MEMO

RE: Riverside Village Subdivision, Garden City, ID - Water Right and Water Measurement Device Review and Recommendations

Figure 2 - Detailed Riverside Village Exhibit Map

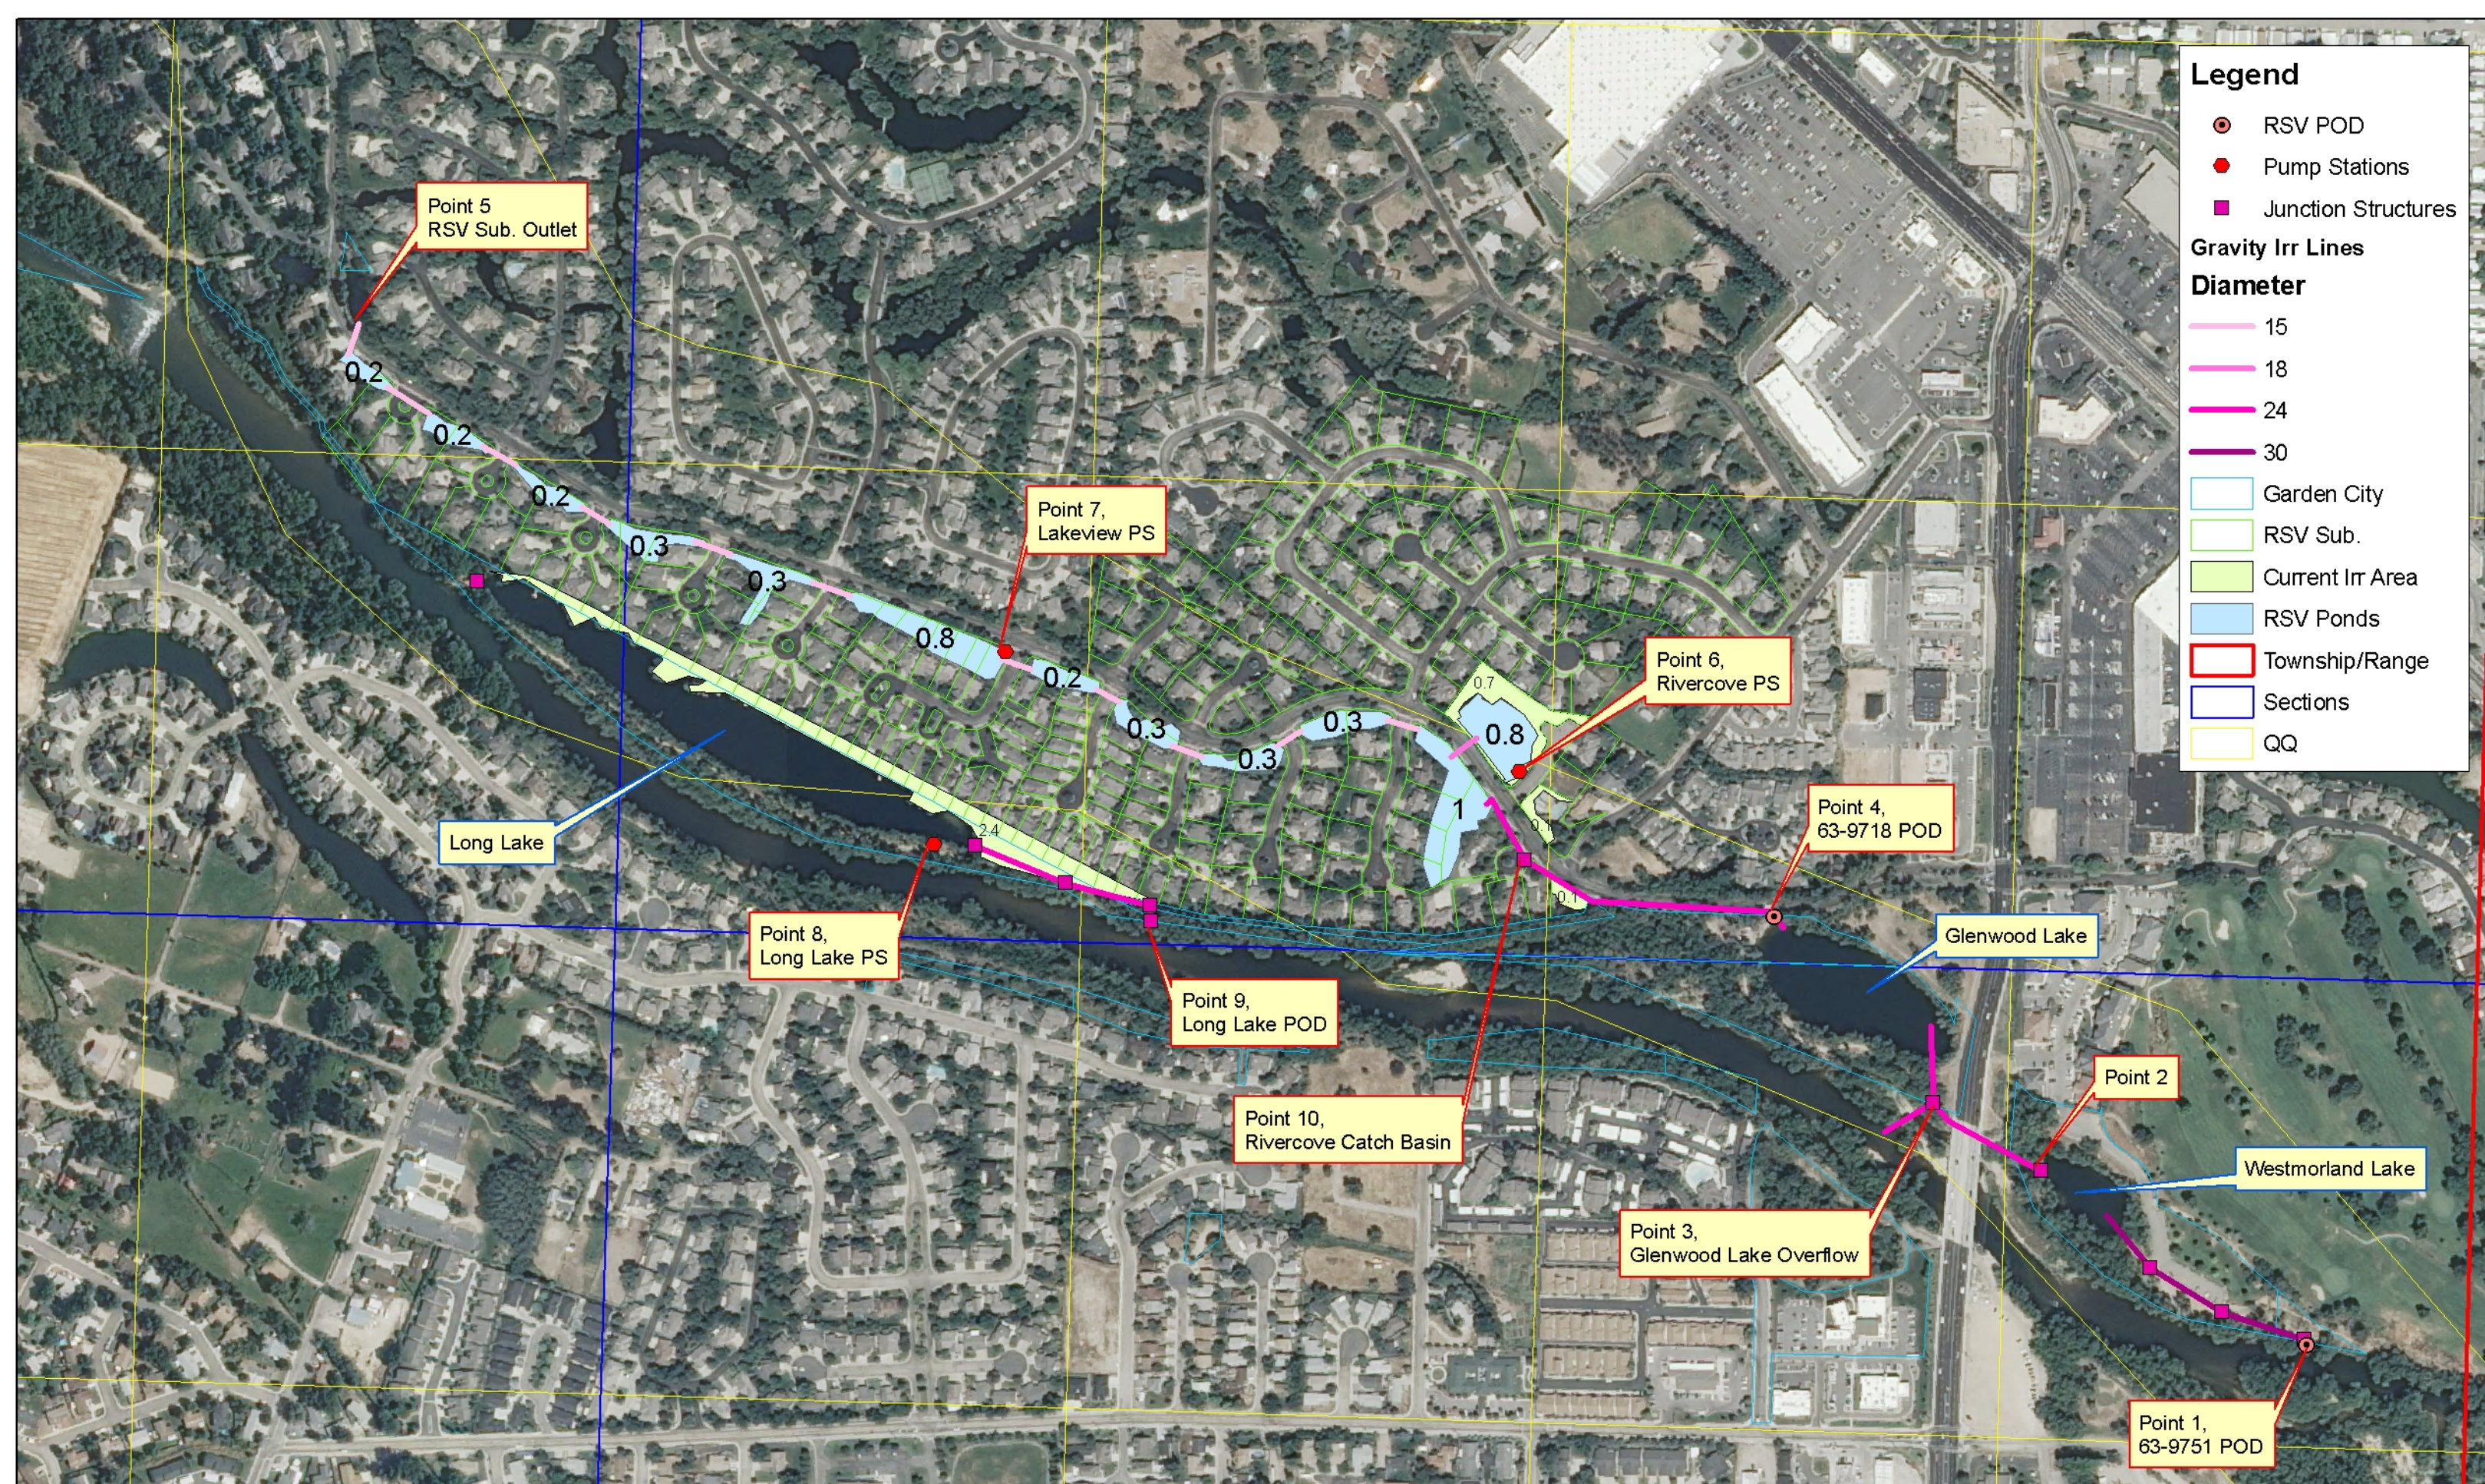
Water is initially diverted into the system at a POD, consisting of a 30-inch diameter pipe and headwall, located at the east end of Westmorland Park approximately 0.2 miles upstream of the Glenwood Bridge (Point 1 on Figure 2). There is no control device on the existing head works. The 30-inch diameter pipe traverses approximately 630 feet to the west before discharging into the east end of Westmorland Lake. Between the POD and the discharge into Westmorland Lake the gravity irrigation line passes through three concrete junction structures (approximately 4 ft x 4 ft). Backwater analysis of this system at minimum design flow indicates that the only section of pipe flowing full was the downstream-most section. This analysis was consistent with observed field conditions during the site visit. Water discharges from Westmorland Lake via a square concrete structure located on the west end of the lake (Point 2 on Figure 2). Three sides of the structure have screened rectangular openings that pass water into the downstream diversion pipe. The elevation of the rectangular openings dictates the maximum water surface elevation (WSE) of Westmorland Lake.

From the outlet box on Westmorland Lake approximately 415 linear feet (LF) of 30-inch diameter pipe conveys water to an overflow structure located near the paved greenbelt path on the west side of Glenwood Bridge (Point 3 on Figure 2). This overflow structure is in approximately the same location as the original POD of water from the Boise River into Glenwood Lake. Discharging into the overflow structure is the 30-inch diameter pipe that drains Westmorland Lake. Discharging out of the overflow structure is 24-inch diameter pipe, which supplies water to the east end of Glenwood Lake. A screened rectangular opening is located in the west face of the overflow structure that allows water to overflow out of the device and back into the Boise River. The elevation of this rectangular opening dictates the maximum WSE of Glenwood Lake. At the time of the site visit the conveyance line from Westmorland Lake to Glenwood Lake was flowing full under modest head. An outlet out of Glenwood Lake is located at the west end of the lake (Point 4 on Figure 2). This outlet consists of a head wall and lockable canal gate that allows for the regulation and control of discharges out of Glenwood Lake and into the RSV Subdivision pond system.

From the outlet of Glenwood Lake water is conveyed via 24-inch gravity irrigation pipe approximately 1,056 LF to the west/southwest where it discharges into the uppermost pond in the RSV Subdivision. At the time of the site visit the conveyance line from Glenwood Lake to the uppermost RSV Subdivision pond was flowing full under modest head. This pond is in hydrologic equilibrium with a second pond located across Riverside Drive to the north. From the uppermost pond(s) water is conveyed downstream, to the west, through a series of ten sequential ponds, bringing the total number of ponds within RSV Subdivision to 12. Each pond is connected to the pond immediately downstream and upstream by a 15-inch diameter concrete culvert. Water discharges from the lowermost pond in the subdivision under Riverside Drive and into another pond located within the Woods at Riverside No. 3 Subdivision (Point 5 on Figure 2).

Two irrigation pump stations divert water from the series of 12 ponds located within the RSV Subdivision. The first pump station (Rivercove PS; Point 6 on Figure 2) diverts water from a 0.8-acre pond located at the head of the system. This pump station was acknowledged in the Beneficial Use Field Report conducted by the Department. Irrigation associated with this pump station was also identified in the Field Report. The second pump station (Lakeview PS; Point 7 on Figure 2) diverts water from another 0.8-acre pond located near the middle of the pond system. This pump station was not constructed at the time the field exam was conducted.

A third irrigation pump station (Long Lake PS; Point 8 on Figure 2) is located near the east end of Long Lake on the south side or river side of the lake. This was the second pump station identified in the Beneficial Use Field Report and the irrigation associated with this pump station was also acknowledged in the report. Water is diverted from the Boise River into Long Lake at an uncontrolled diversion located approximately 0.1 miles upstream of Long Lake (Point 9 on Figure 2). Water is conveyed from the point of diversion via approximately 597 LF of 24-inch diameter PE pipe passing through two irrigation junction structures before discharging into the east end of Long Lake. Water flows out of the west end of Long Lake at two points, one point discharges over a concrete check dam and directly into the Boise River, the second discharge point is into Riverside Creek, which itself eventually drains back into the Boise River.

3. Install staff gage in the N. Rivercove Place catch basin.
4. Modify POU
 - a. Pond POU: Eliminate Glenwood Lake and include all twelve lakes currently existing in the RSV Subdivision, refer to Figure 2 for graphical depiction of all RSV ponds.

- b. Irrigation POU: Modify irrigation POU to depict irrigation as it actually occurs today. Irrigation has been described as the north and east shores of Long Lake, a 20-foot buffer around all 12 lakes, irrigation of club house lot, and irrigation of subdivision entrance open space lot, refer to figure 2 for graphical depiction. Note this POU should be verified at the time of transfer.

4. Modify POU to eliminate Glenwood Lake and include all 12 lakes currently existing in the RSV Subdivision, refer to Figure 2 for graphical depiction of all RSV ponds.
